MEISMAN PROPERTY

GRADING AND EROSION CONTROL PLAN

EPC STORMWATER REVIEW COMMENTS ARE SHOWN IN ORANGE BOXES WITH BLACK TEXT

PPR-21-073

MEISMAN PROPERTY
GRADING AND EROSION CONTROL PLAN
EROSION CONTROL PLAN

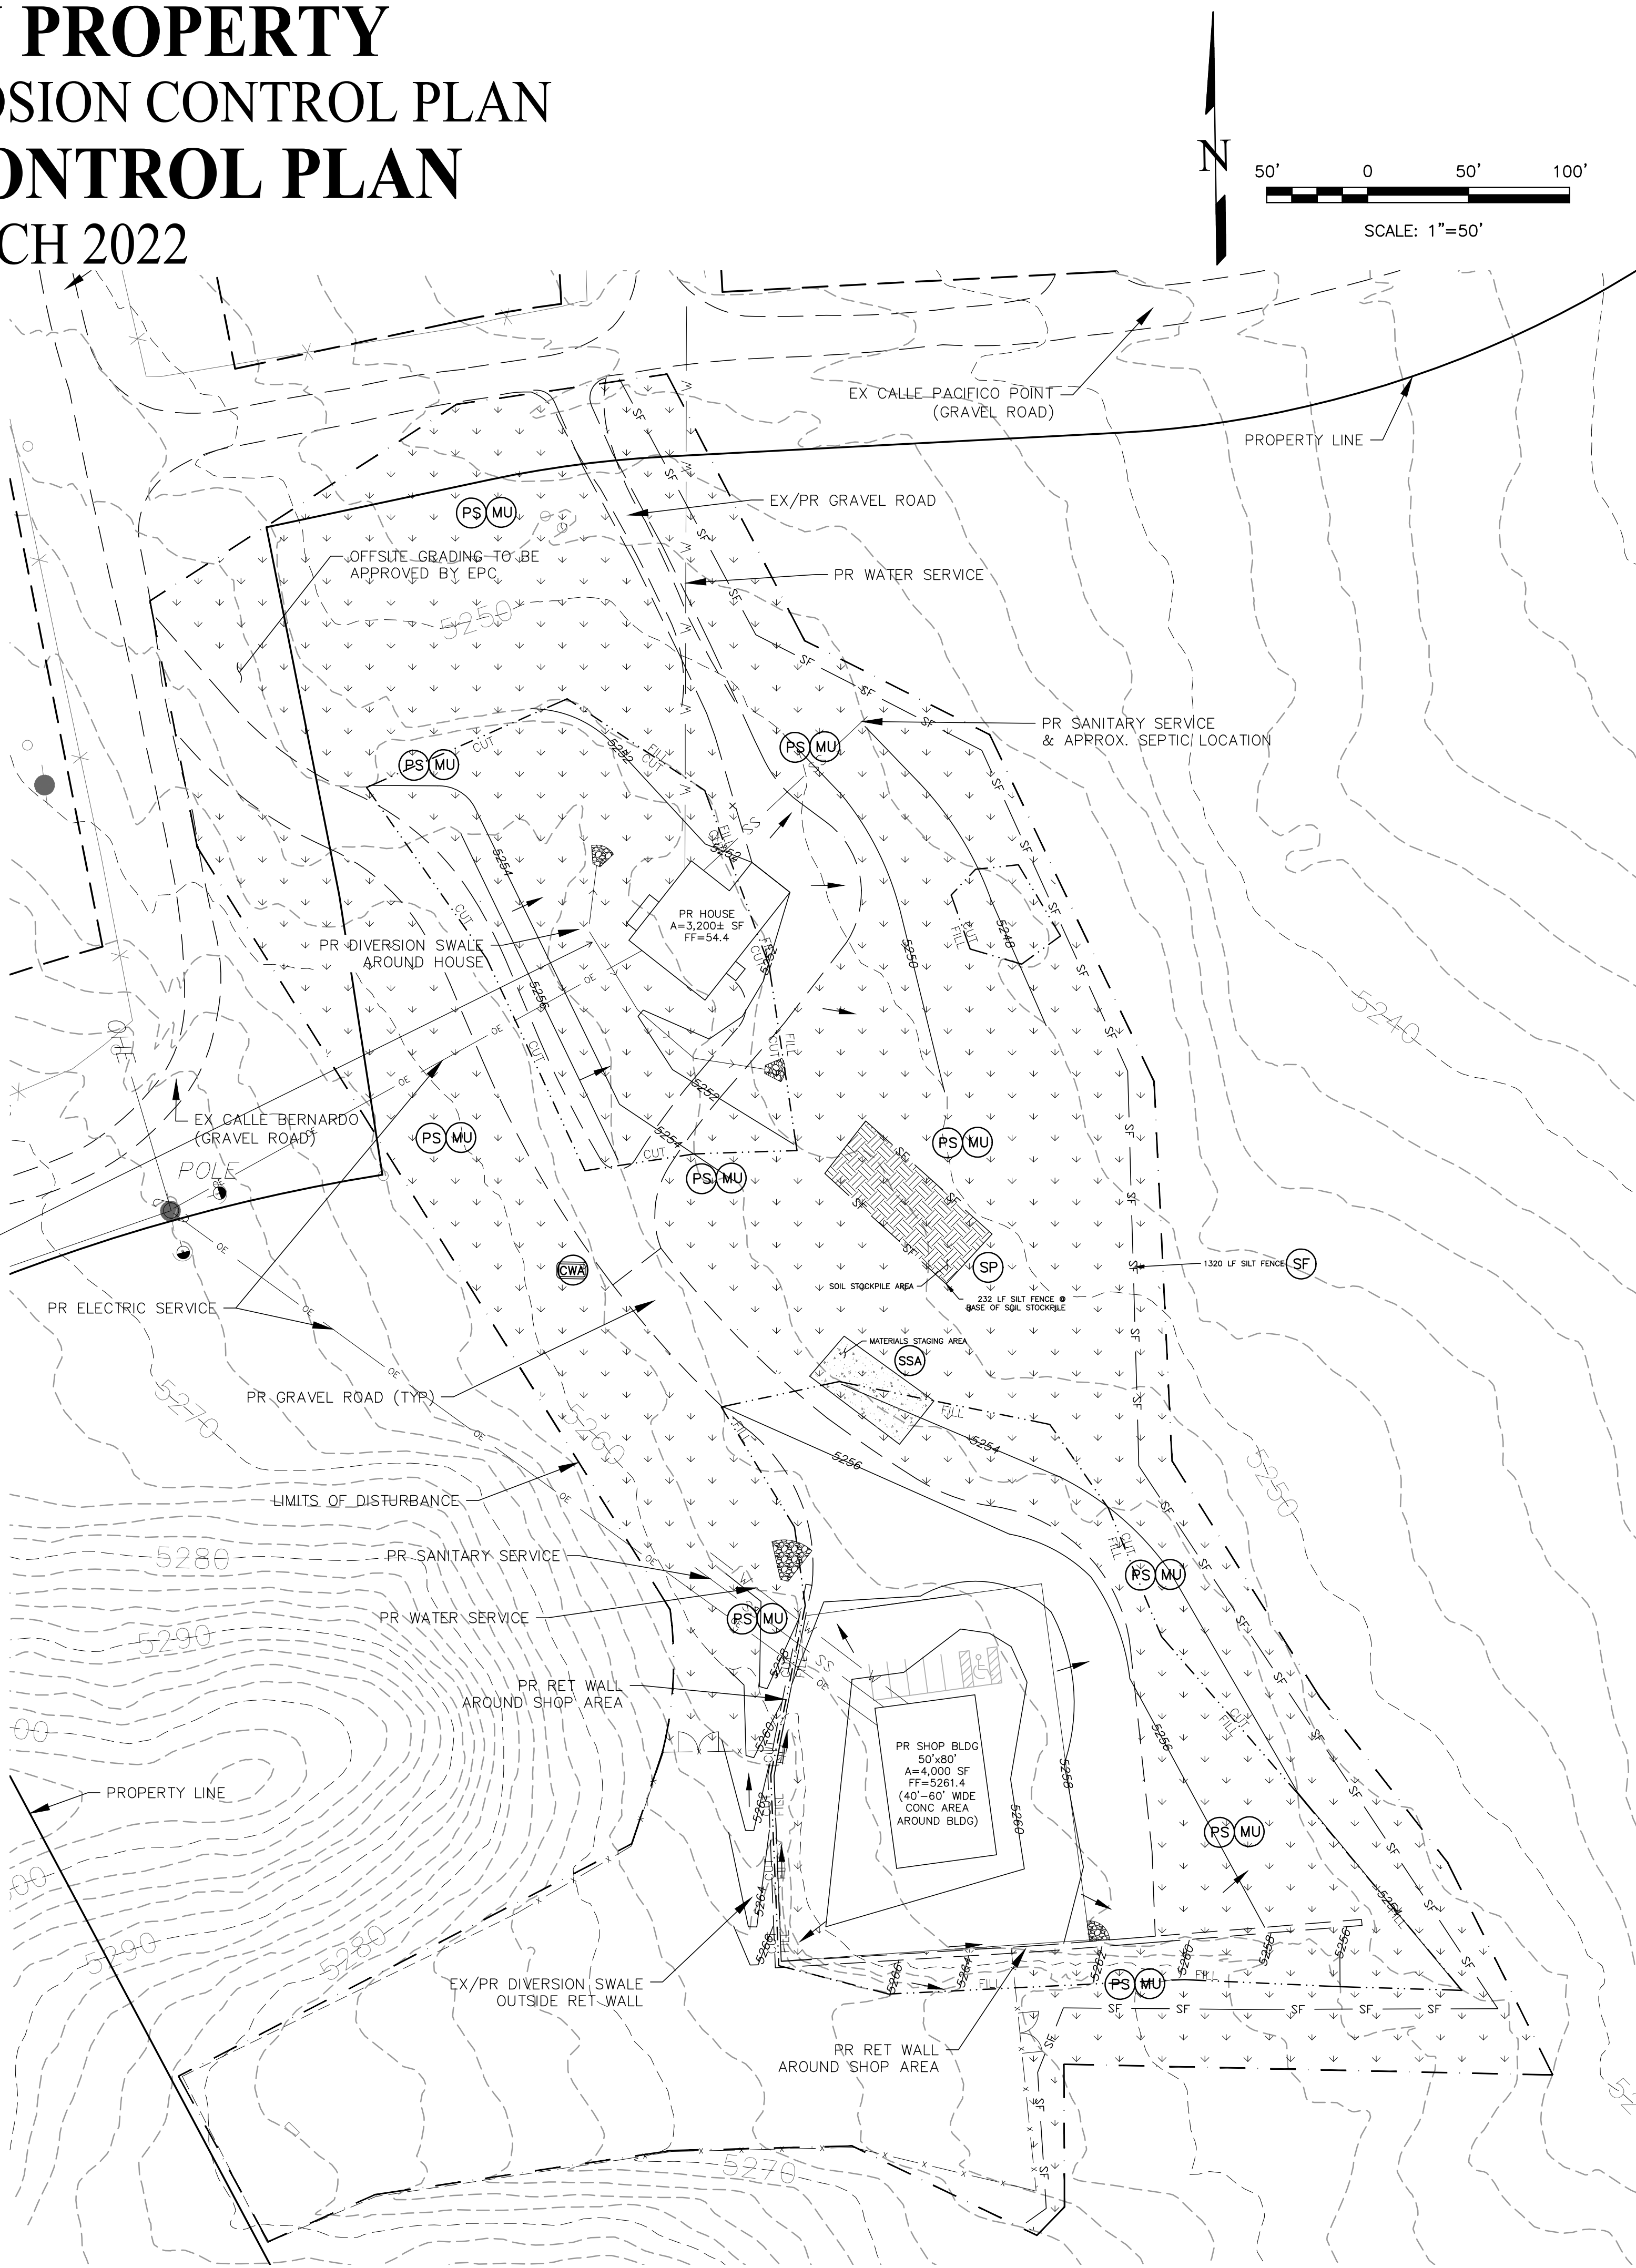
show swale contours
or provide a typical
swale cross section
detail.
Unresolved.
